Elevation QA Review Report

Project: **Fulton County, GA** **Contractor:** **3001, Inc. and Ayres Associates**

Seam Line Attachments:

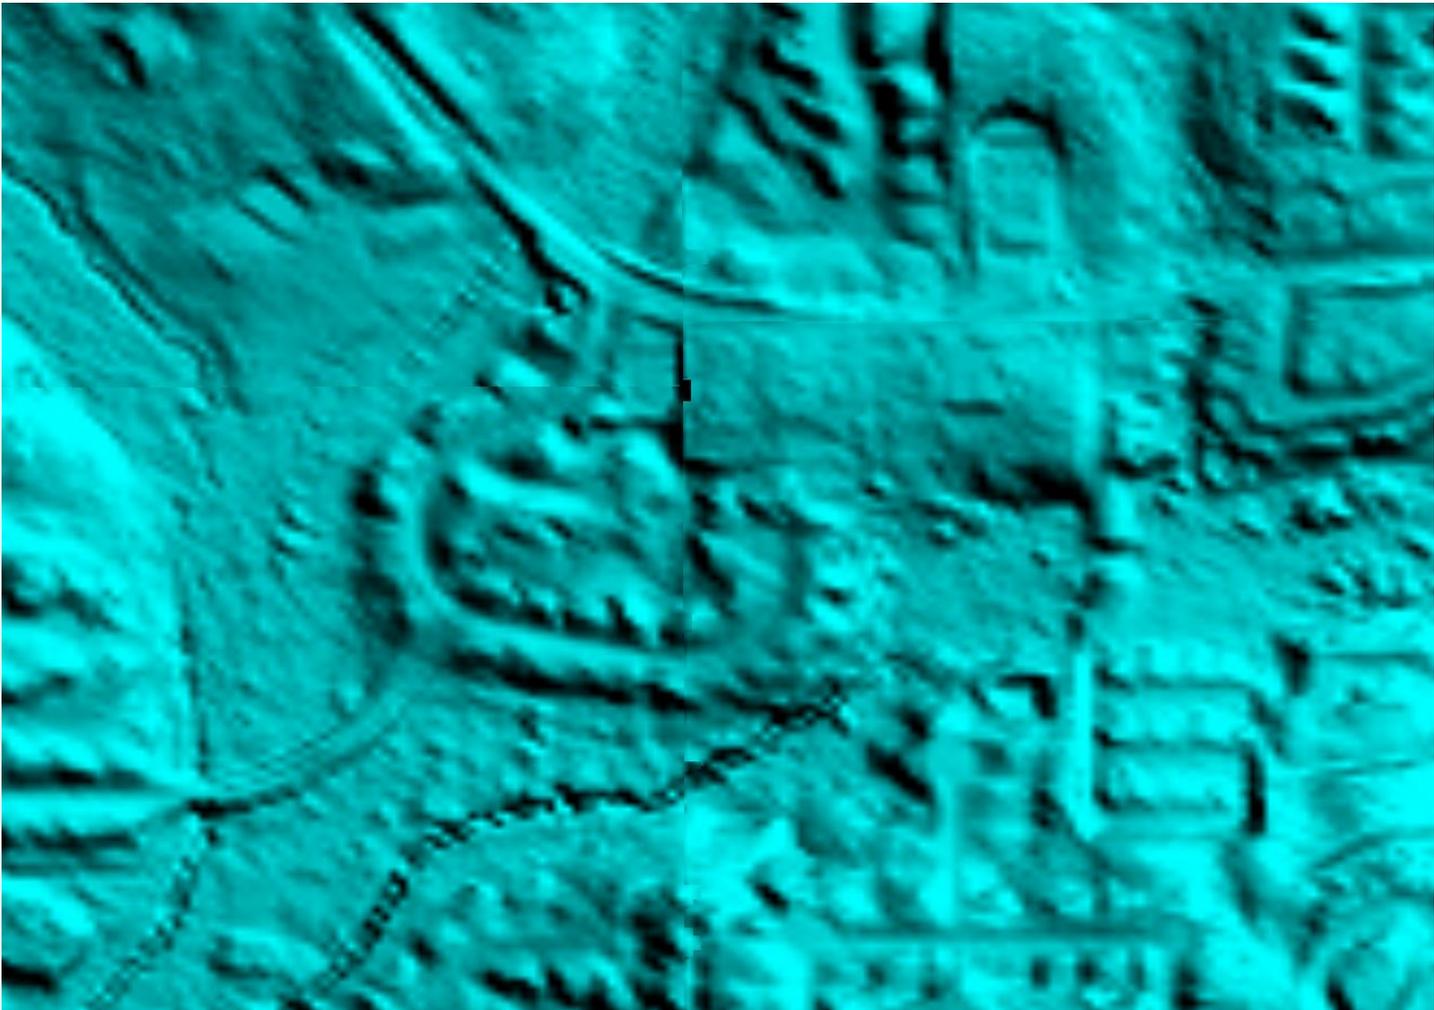
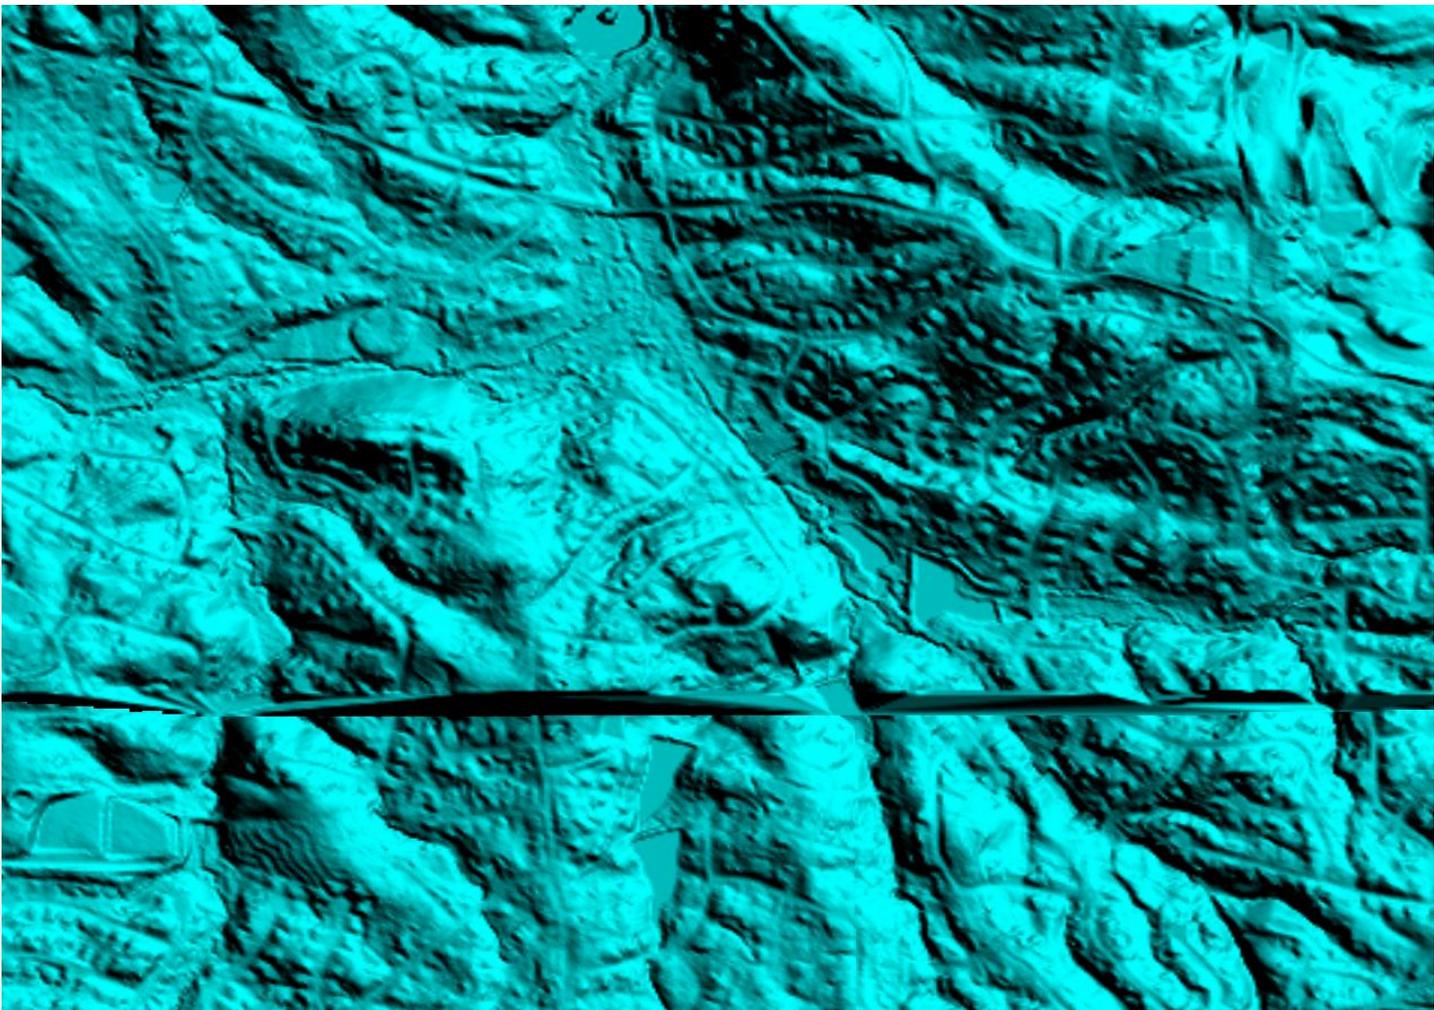
All seam lines are visible; see attachments for representative examples.

Failure to Flatten:

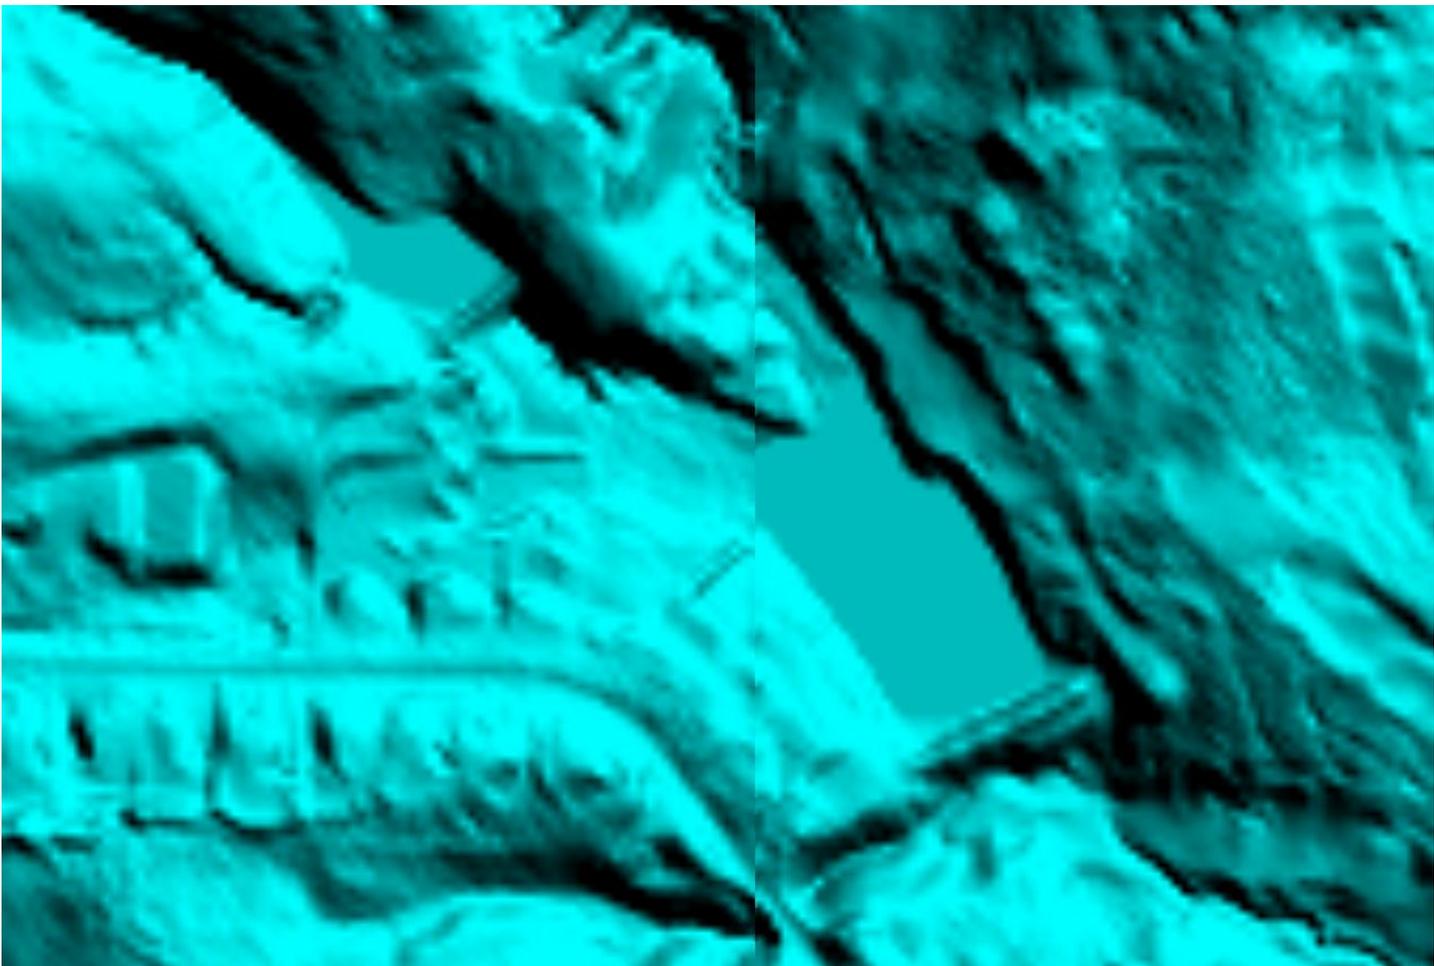
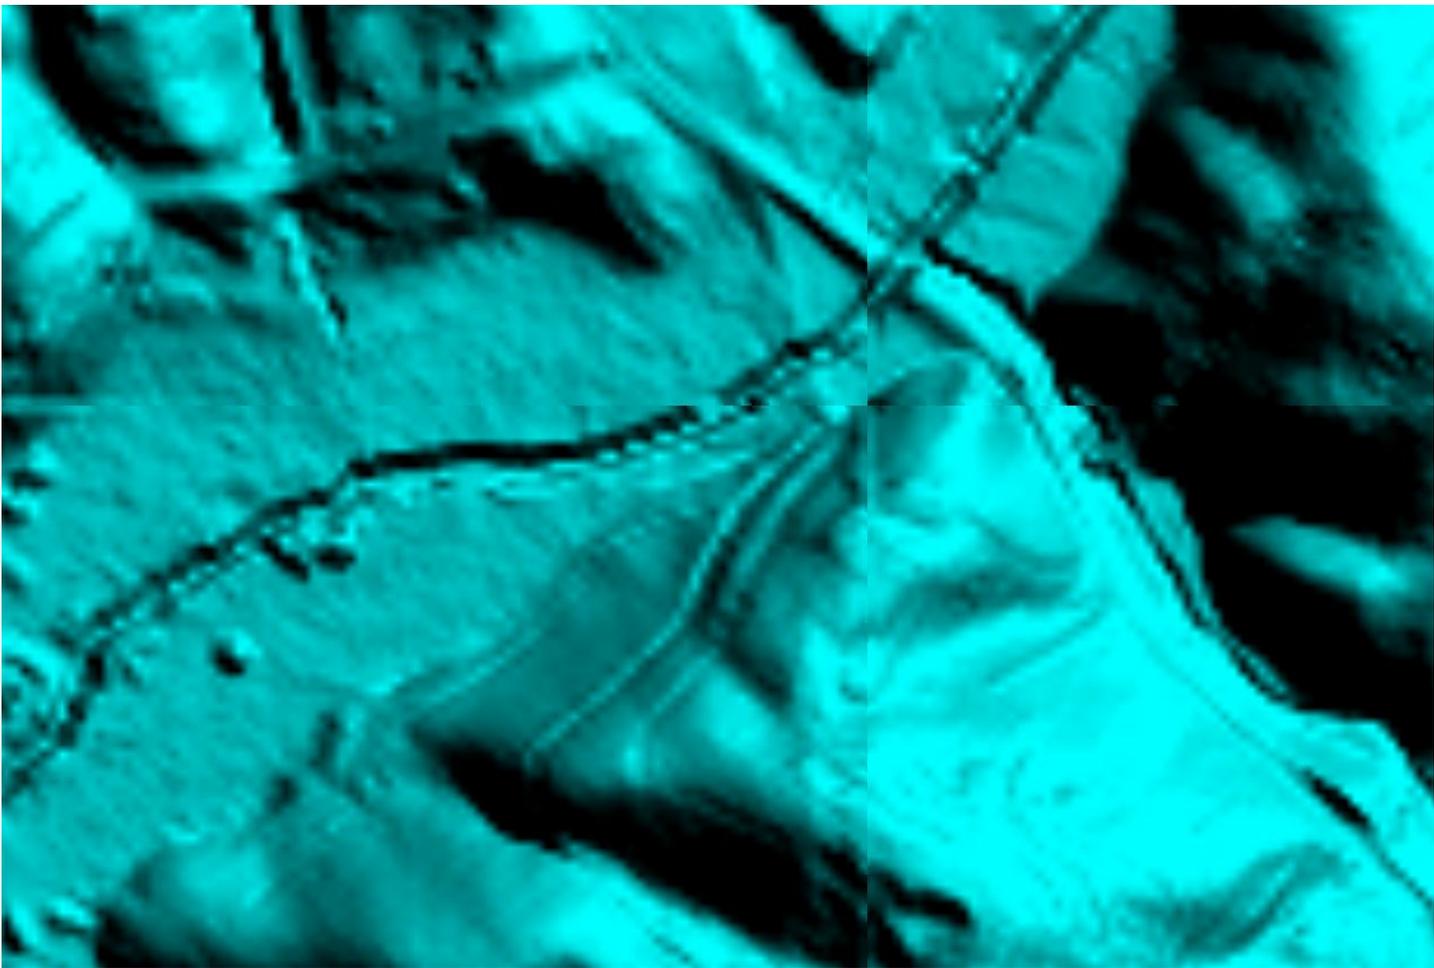
Water bodies were found that were hydro-flattened incorrectly; see attachment for an example.
